KANEPACKAGE PHILIPPINE INC.

INVESTIGATION REPORT FORM (IRF)

Customer	EPSON PRECISION PHILS. INC.- ASP/EPLB	Attention To	REXEL ALMARIO
Item Code	511594700-EQOS	Department	PRODUCTION
Item Description	BOX	Date of Detection	250228
Job Order Number	JO25-M-00574-4	Section Detected	QA SCREENING

ILLUSTRATION OF THE PROBLEM

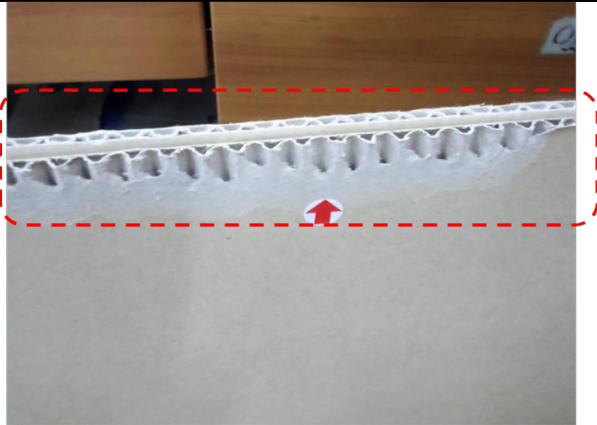
ACTUAL: PEEL OFF UP TO 120MM.

REQUIREMENT: ACCEPTABLE UP TO 25MM.

PEEL OFF

PEEL OFF UP TO 120MM

WHY 1 : The liner get caught at the Eqos feed gate during running.

WHY 2 : Materials encountered warpage.

WHY 3 : Lacking of weight jig

WHY 1: Provision of additional weight jig to prevent warping of materials. Paper weight jig already disposed as per advised of top management.
